ADDENDUM #2

PROJECT: Bridge Classroom Portable & Relocated Portable at Lawrence ES
Lodi Unified School District

REF. # : District Project No. #2600-5870-210-60
DSA FILE # 39-50
Lawrence ES

DATE : January 21, 2026

AA2.2

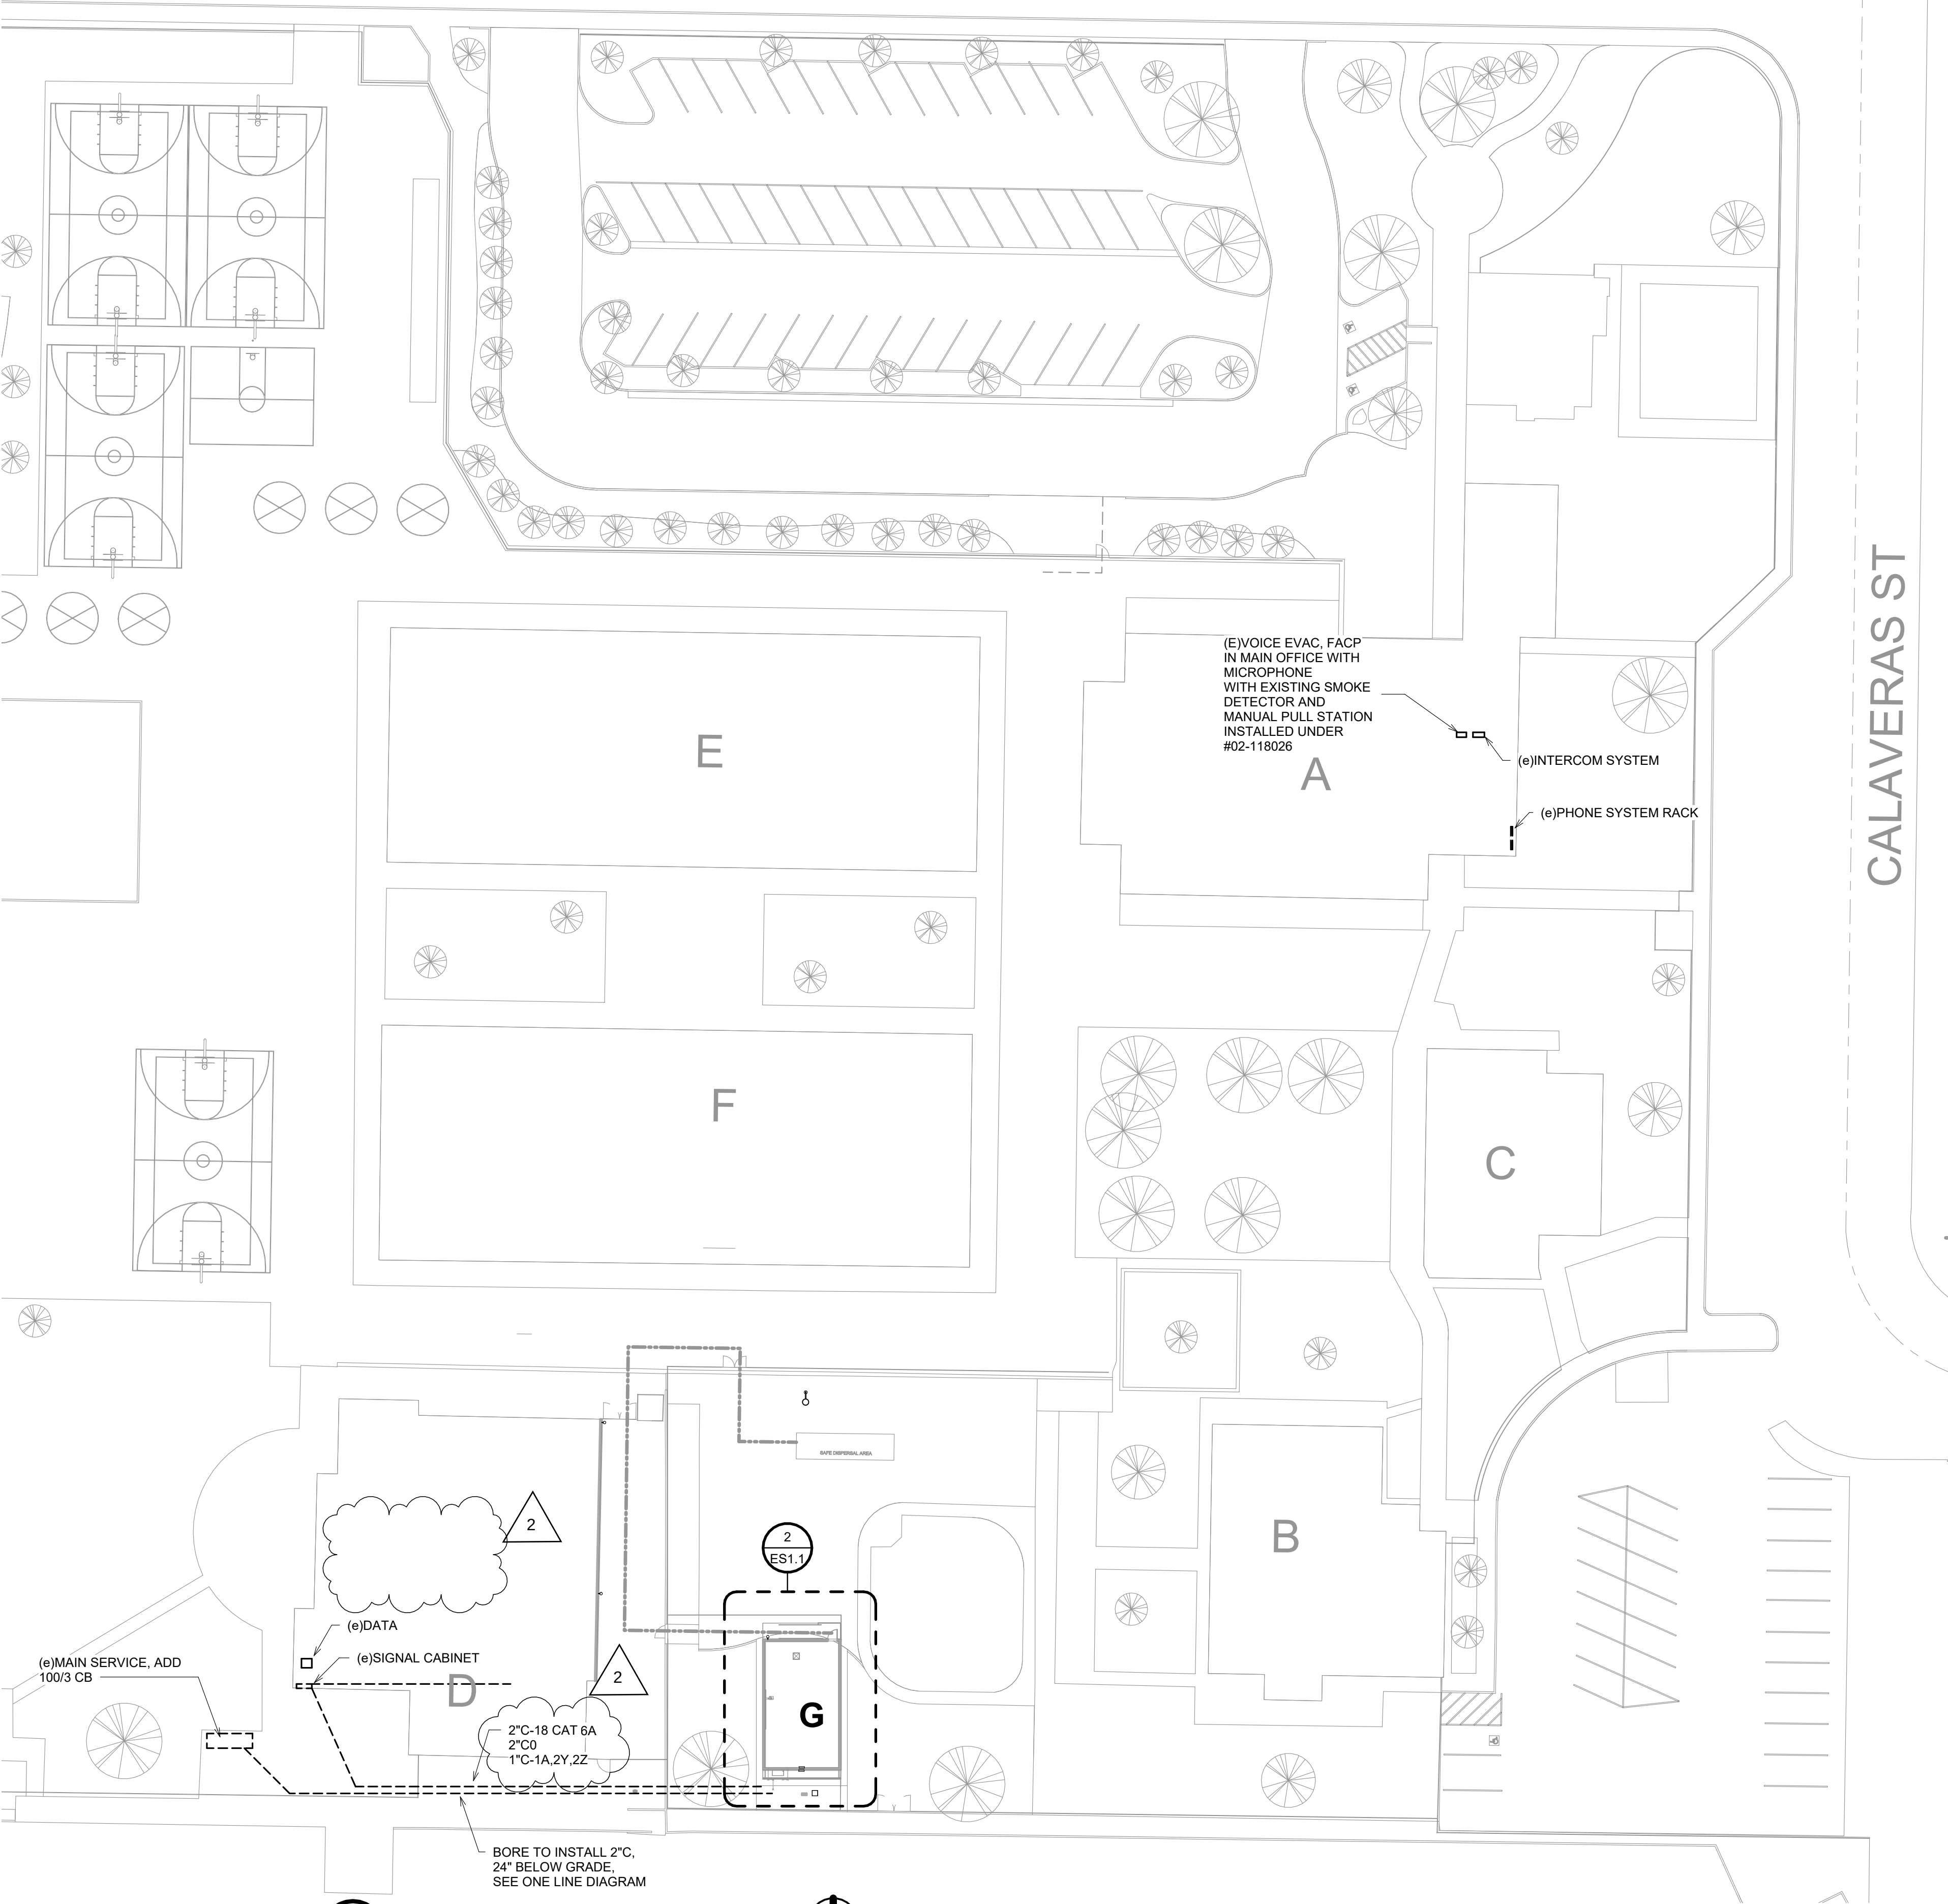
ITEM 5 Window Roller Shades

The Contractor is to provide and install window roller shades at all windows in Unit G (two windows) and Unit H (two windows). Total of four windows. Roller shades are to be Urbanshade Commercial Roller shades from Mechoshade or an approved equal.

1. REPLACE (E) LOCKSET WITH SARGENT 10XG38 CLASSROOM SECURITY LOCK WITH INSIDE LOCK INDICATOR.
2. PROVIDE ALS SIGN IN NEW BUILDING. SEE DETAIL 10/AA1.5
3. PROVIDE WINDOW ROLLER SHADES AT WINDOWS, TYP. FOR 2.
4. PAINT RAMP RAILINGS TO MATCH RAILINGS AT UNIT G AND SURROUNDING SCHOOL SITE COLORS.

ELECTRICAL PLAN

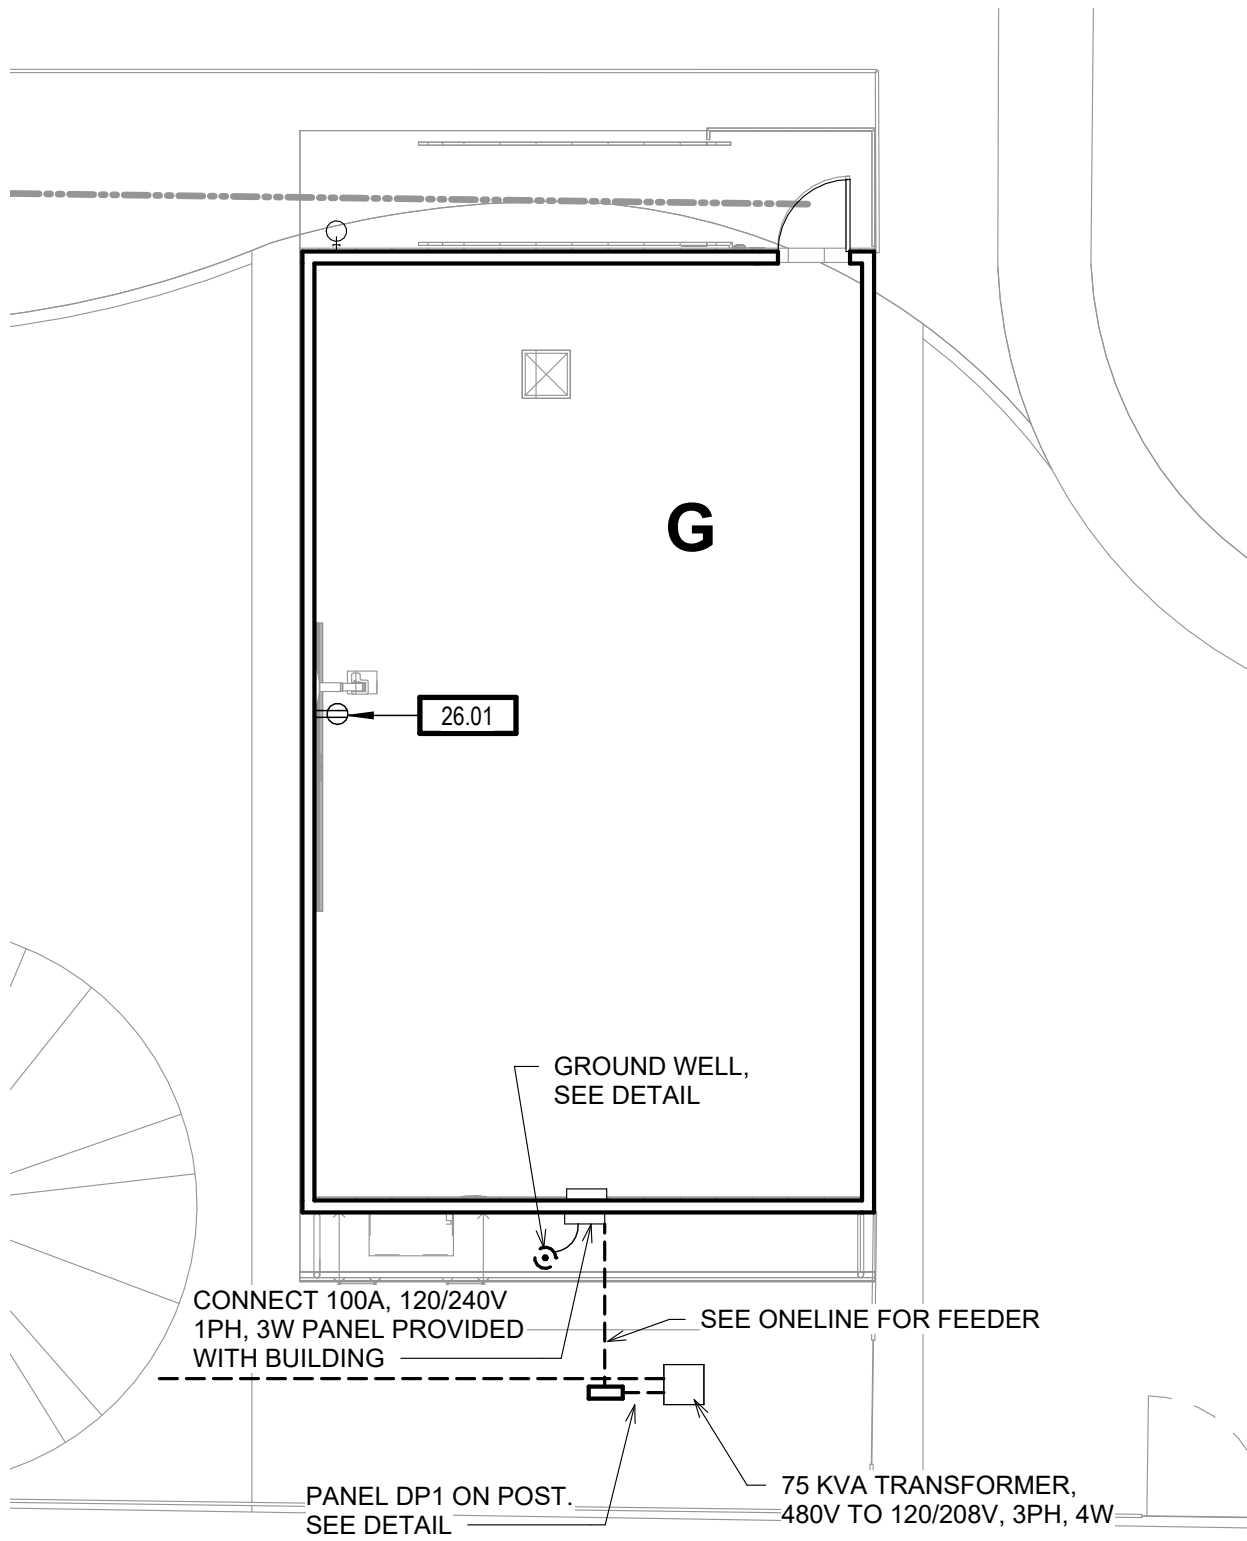
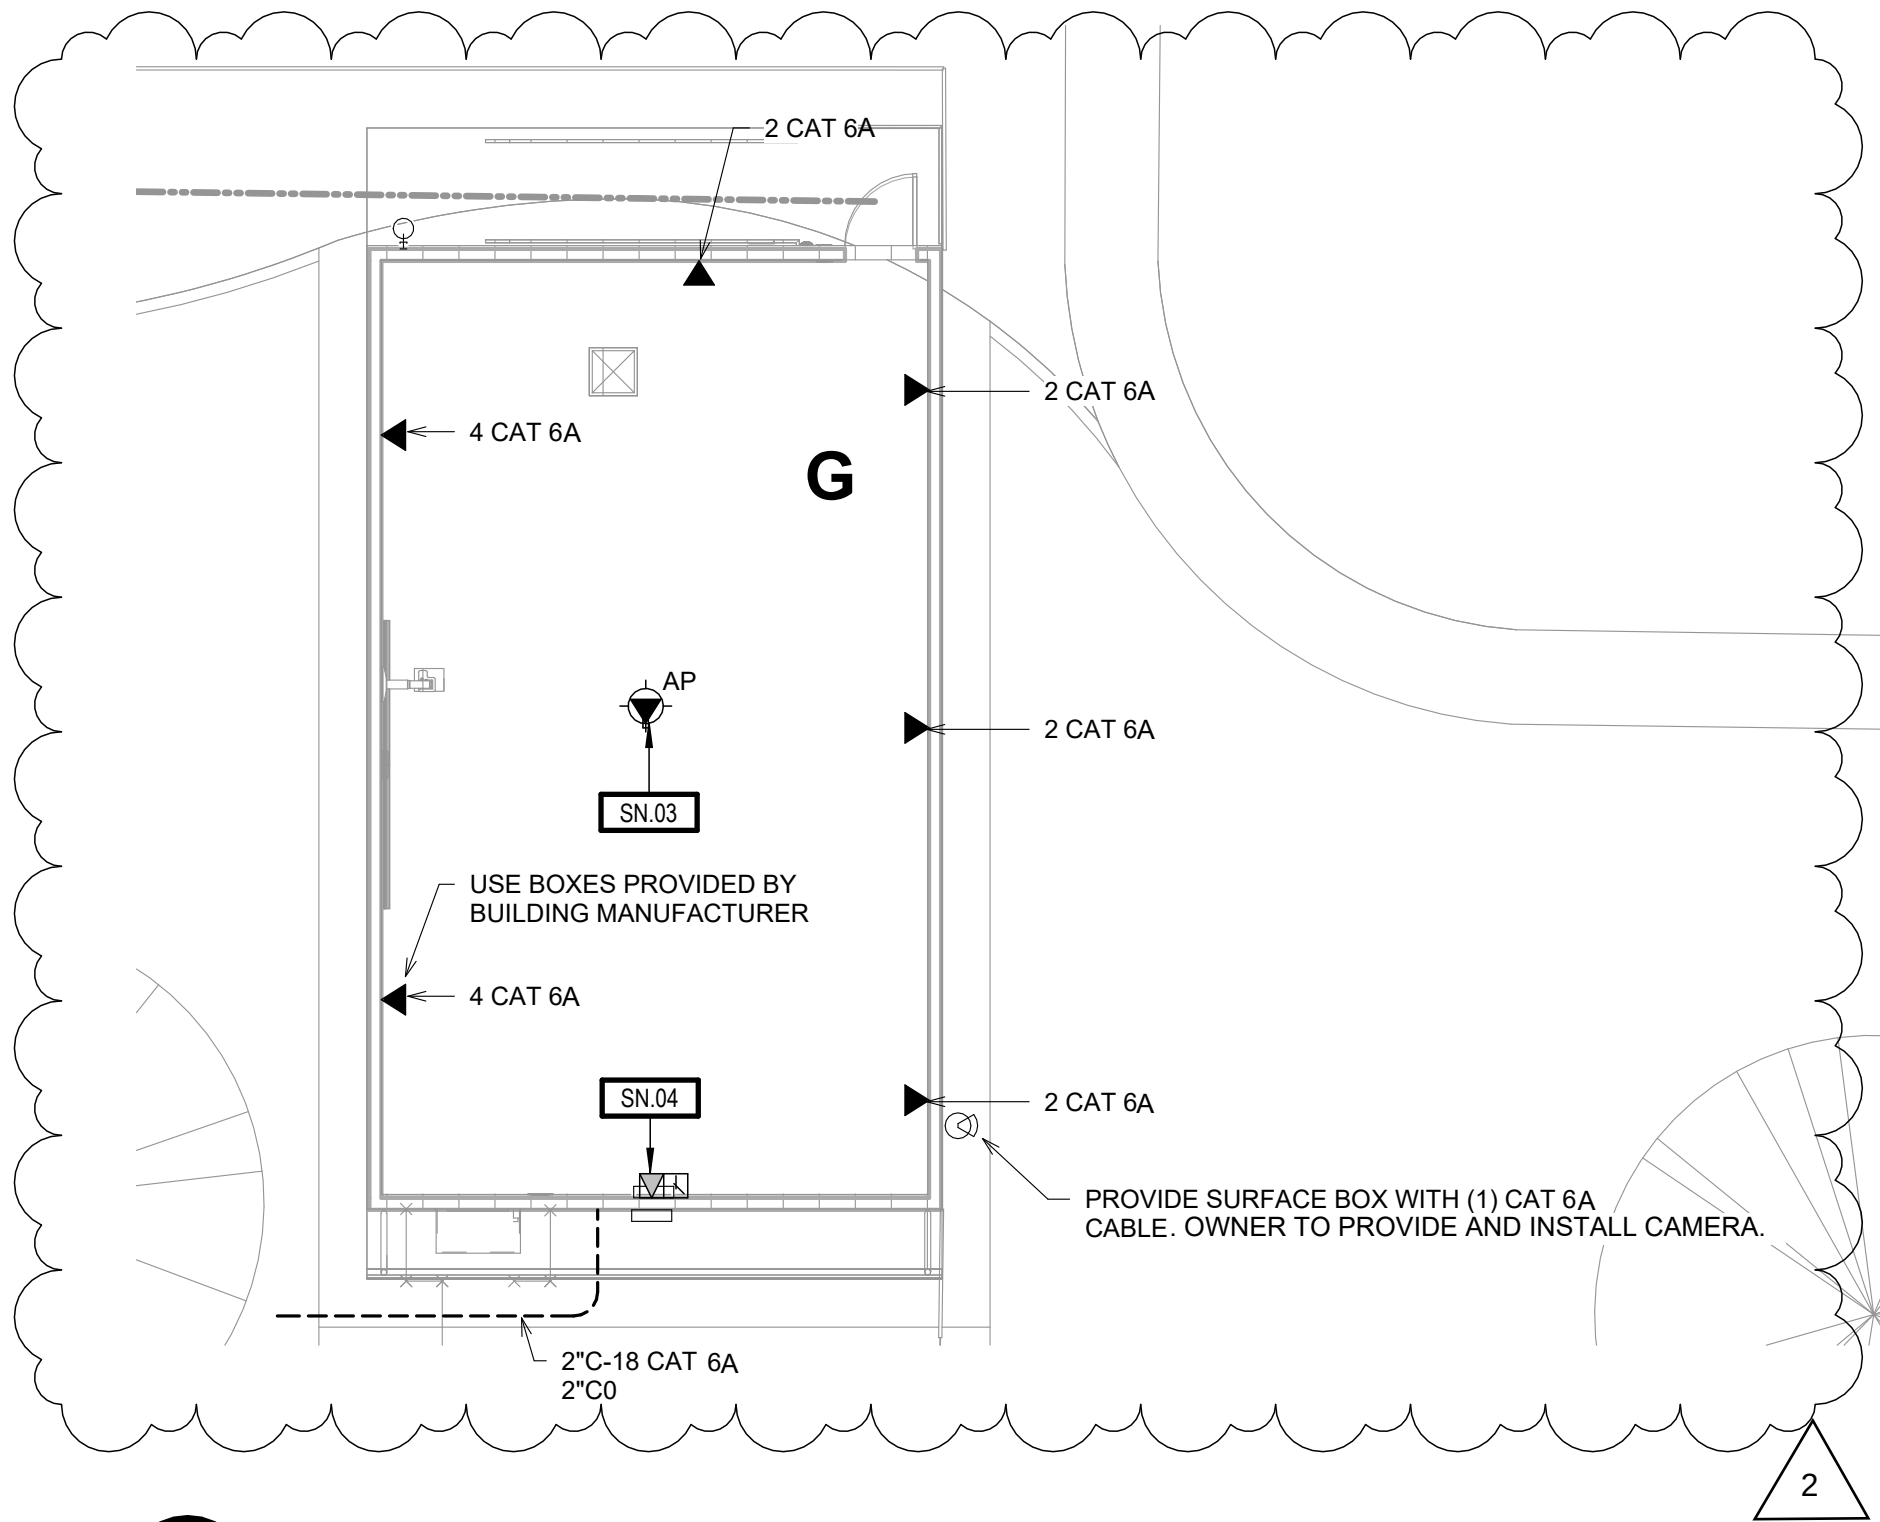
ITEM 1 Provide CAT 6A wiring for phones, data, and intercom systems

All wiring used in the Bridge Portable Classroom building (Unit G) and Relocated Portable (Unit H) at Lawrence Elementary School projects are to be CAT 6A wiring as described on the attached revised sheets 1-ES1.1 and 1-ES2.1 of the DSA approved drawings #02-123434 and #02-123755. Contractor to provide wiring and connections of phone, data, and intercom systems to each building. The District will provide and install the Jive phone/intercom system.
